50 CambridgePark Drive Residences

Cambridge, MA / Supplement to Special Permit Application / August 1, 2018

RE: *Supplemental Application for 50 CambridgePark Drive*

SUPPLEMENT TO SPECIAL PERMIT APPLICATION

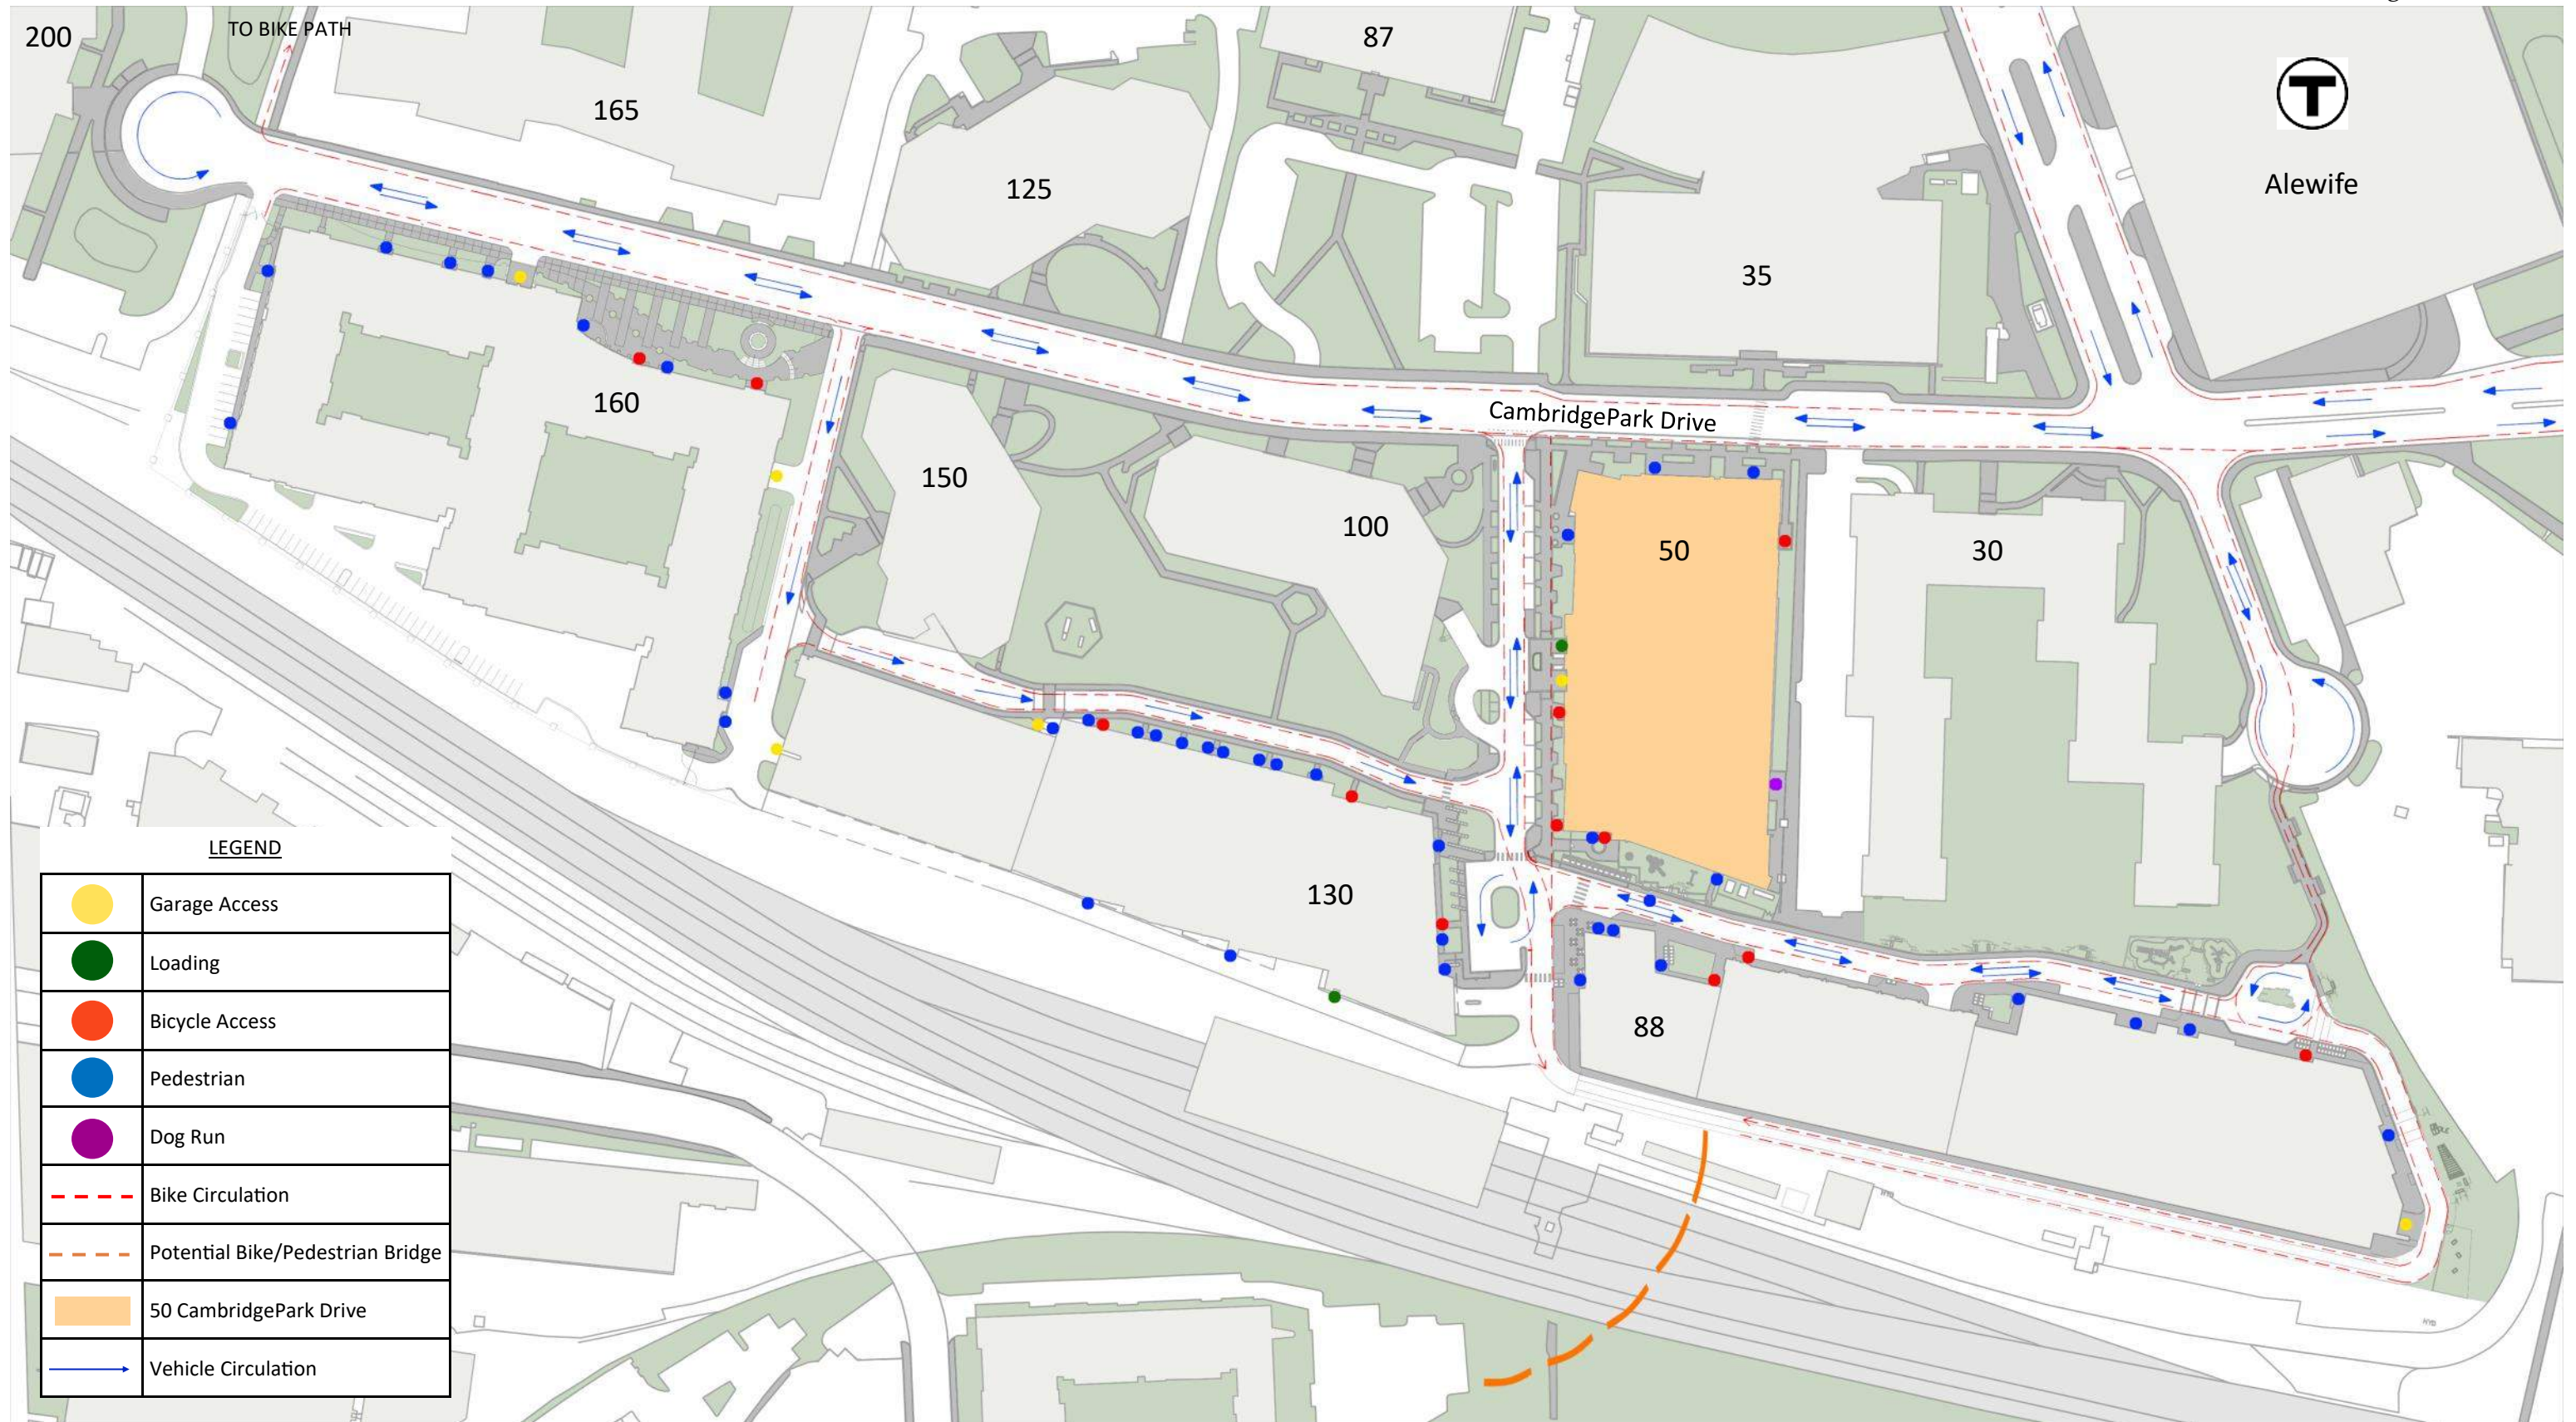
How do the proposed at-grade improvements at 50 CambridgePark Drive, including the new street, bike pathway and pedestrian amenities, connect to the surrounding area and promote a publicly beneficial open space and multi-modal connectivity?

ANSWER The Project will eliminate multiple existing driveways on CambridgePark Drive and replace them with a single curb cut on the new neighborhood street along the Western boundary of the Site, reducing traffic conflicts and improving the pedestrian and bicycle environment on both streets.

The design of the new neighborhood street will strengthen area-wide pedestrian and bicycle connections and allow for connection to a future pedestrian/bicycle bridge over the MBTA commuter rail tracks. This will make it easier for neighbors to access the Project's at-grade open space, which will include a community play area, a bike path, site furniture, and other amenities in the public realm.

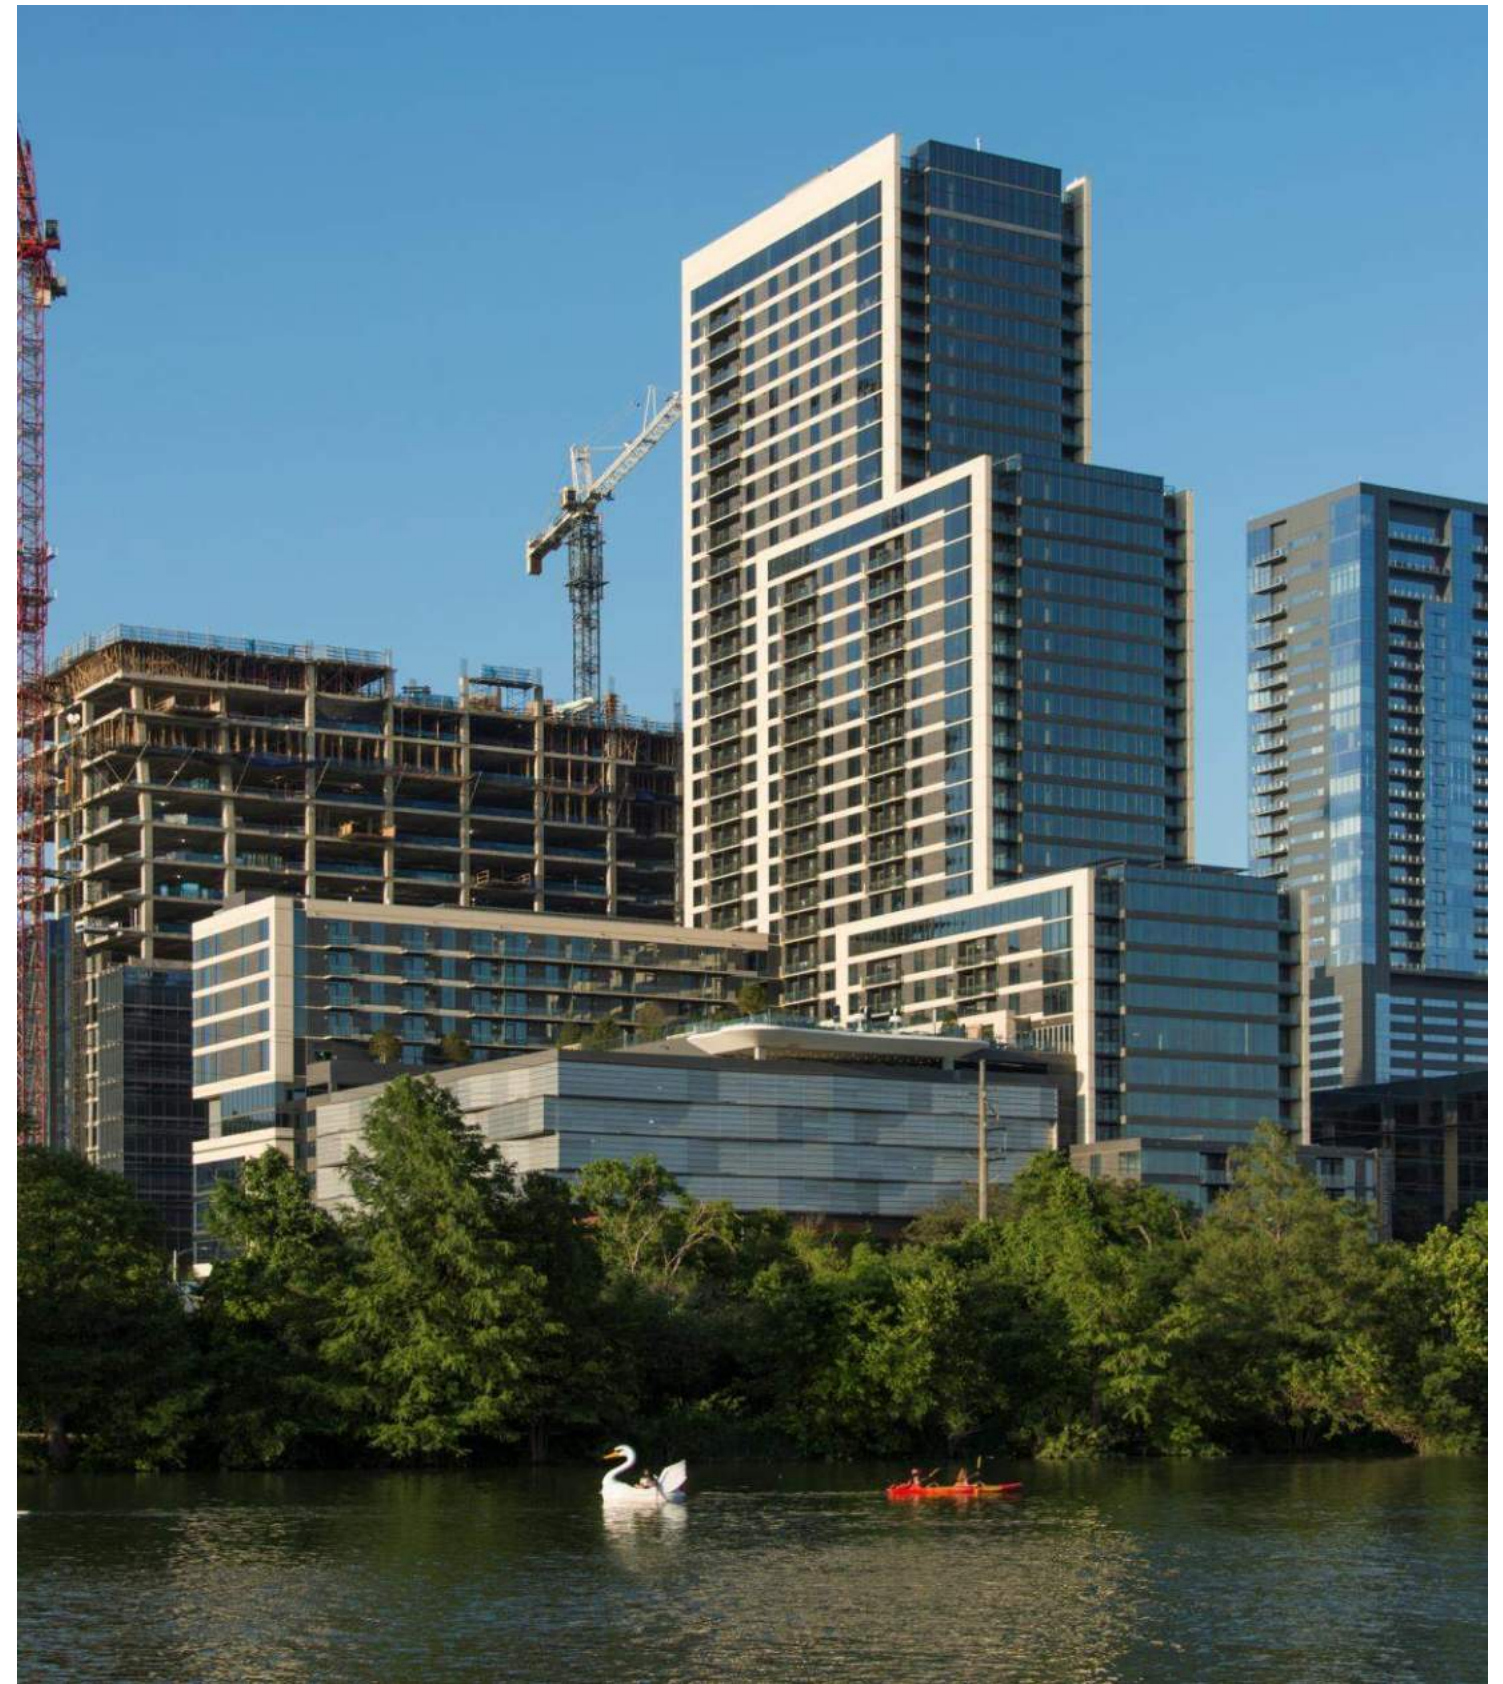
The brick color appears too yellow. Would you reconsider the brick color selection?

ANSWER We did not intend to propose yellow brick for this building. We believe the interior nighttime lighting at our July 10th hearing made the brick color appear significantly different than it does outside in natural light.

For reference, we have provided photos of other projects that also use the proposed brick, and which we believe reflect its true coloring. We respectfully propose that the Board review the actual mock-up samples of the final brick selections on site.
